PLANNING BOARD AGENDA
JANUARY 13, 2022 – 7:00 P.M.

RE: Amended Site Plan
The Hamlet at Carmel
TM# 66.-2-58

DRAWING: OVERALL SITE PLAN

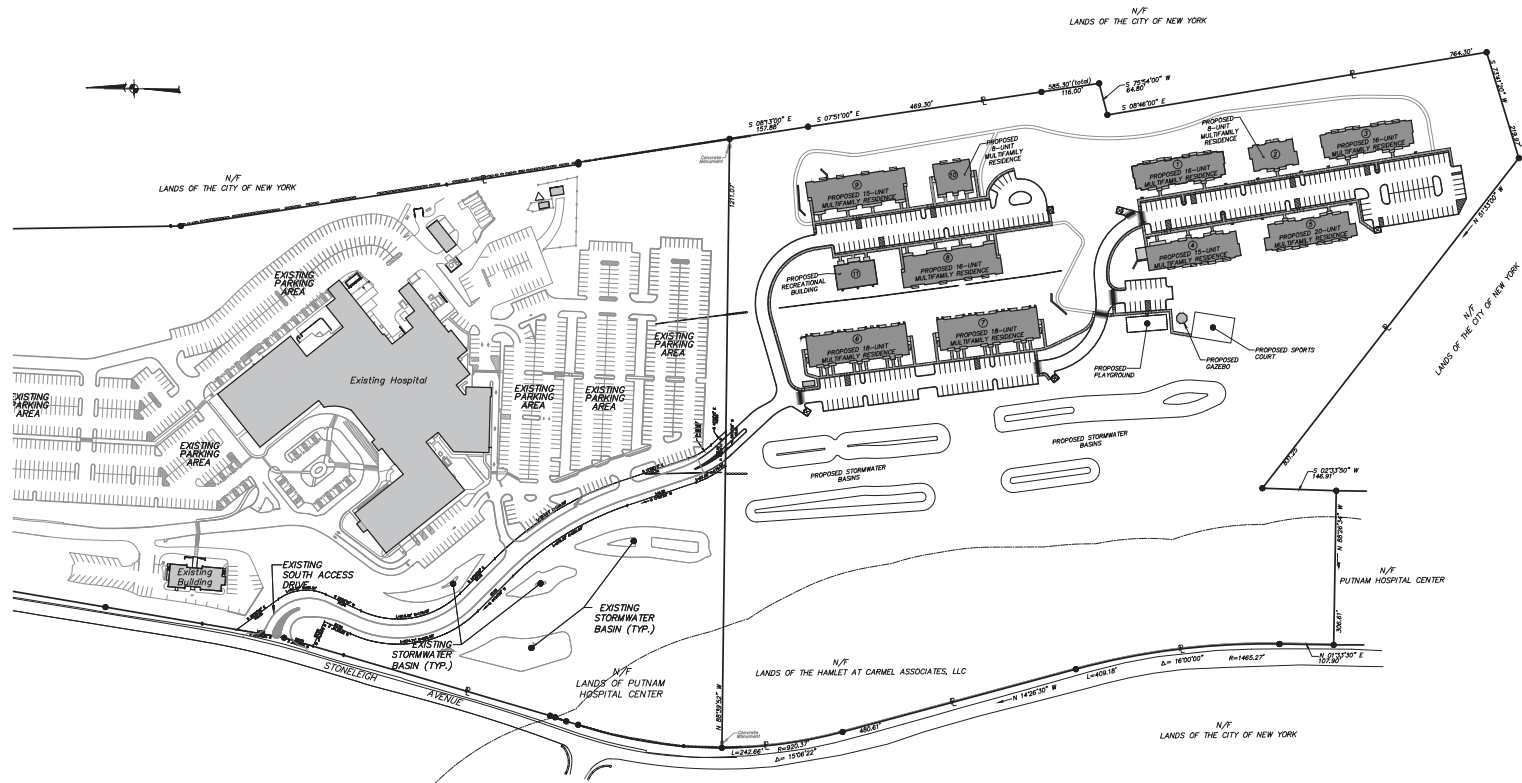
A few other updates should also be noted. The building footprints have been somewhat revised based on general design revisions and in response to the dialogue the applicant's architect has had with the Board's Architectural Consultant. The site as shown continues to be in compliance with zoning requirements and the Zoning Tables on drawing SP-1 have been revised where applicable.

DRAWING: EROSION CONTROL & PHASING PLAN

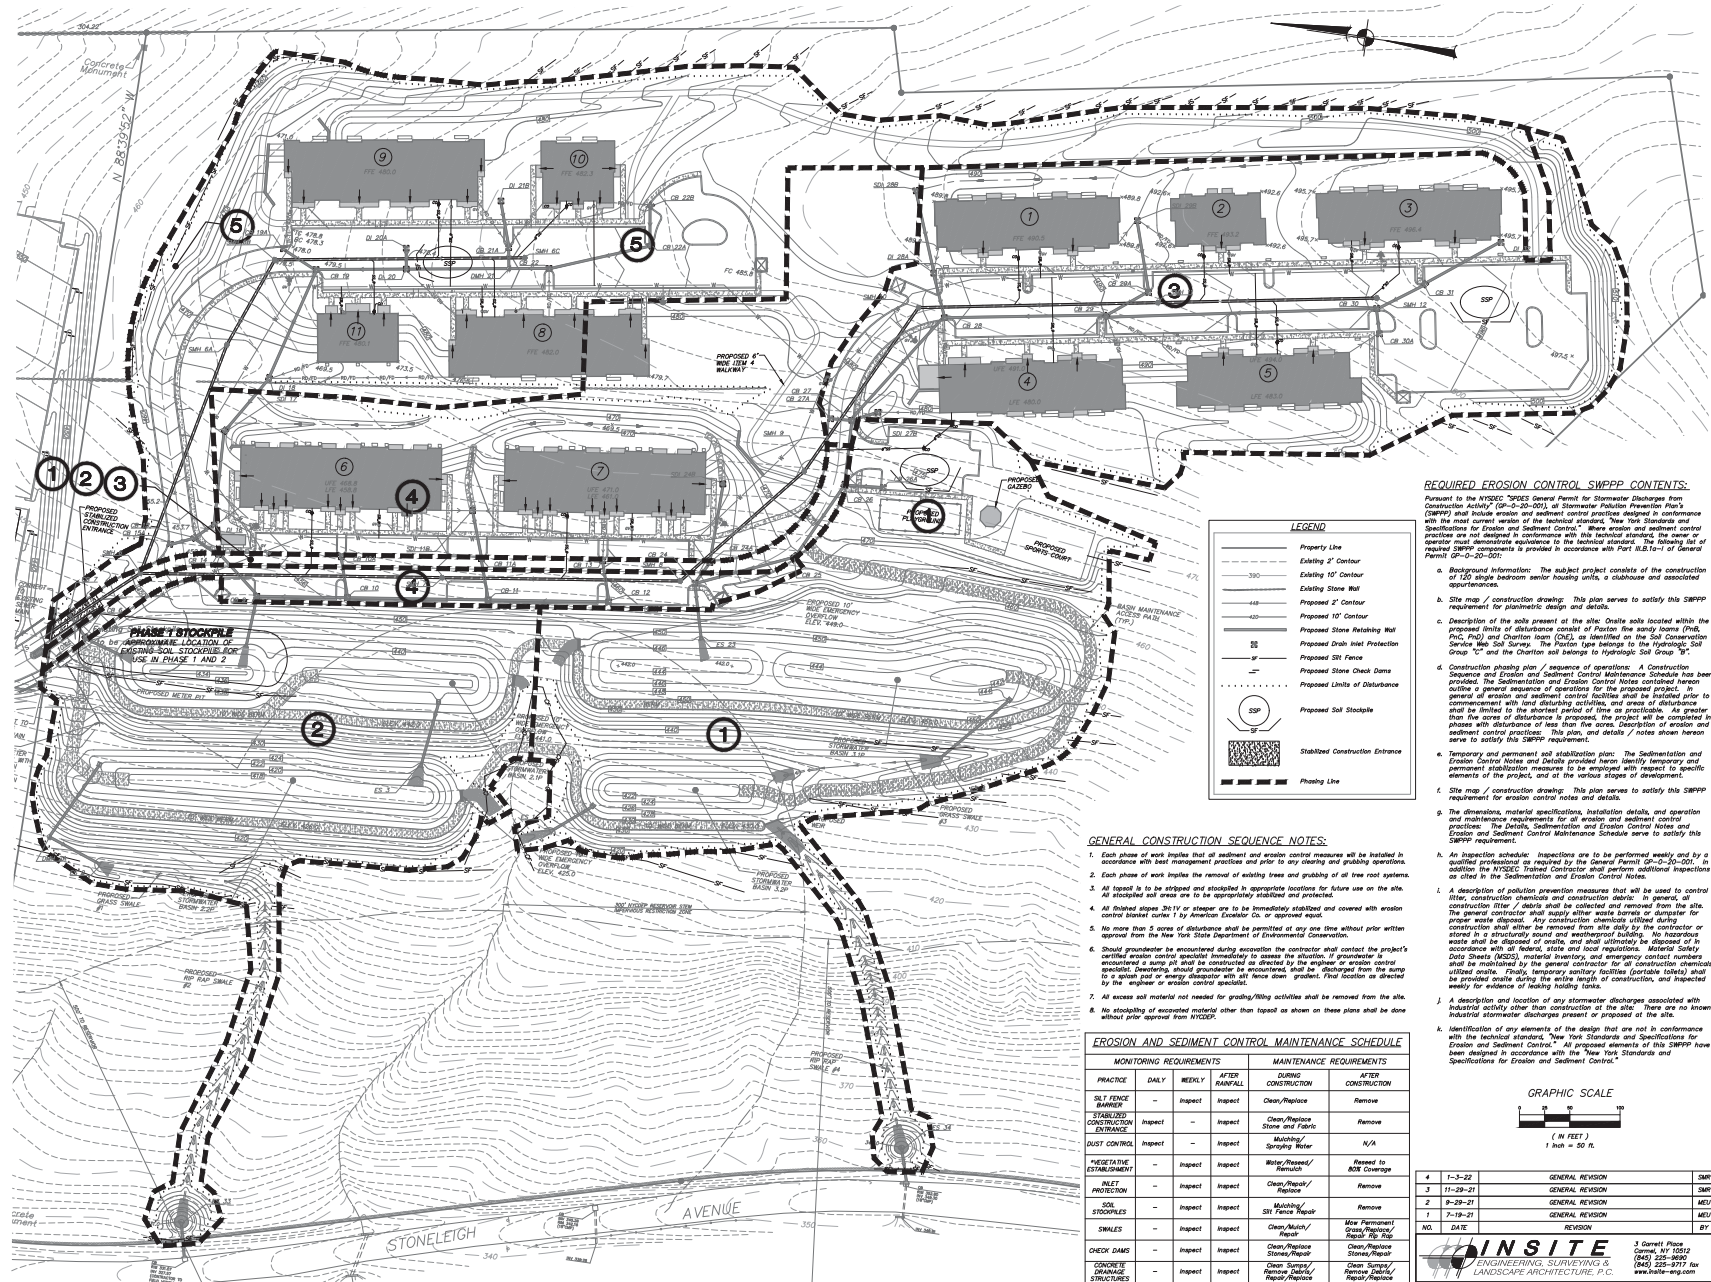
1. See the Certificate of Occupancy Schedule which has been added to drawing SP-4 of the site plan set.
2. As previously noted, adequate water supply is available for the proposed development including fire protection.
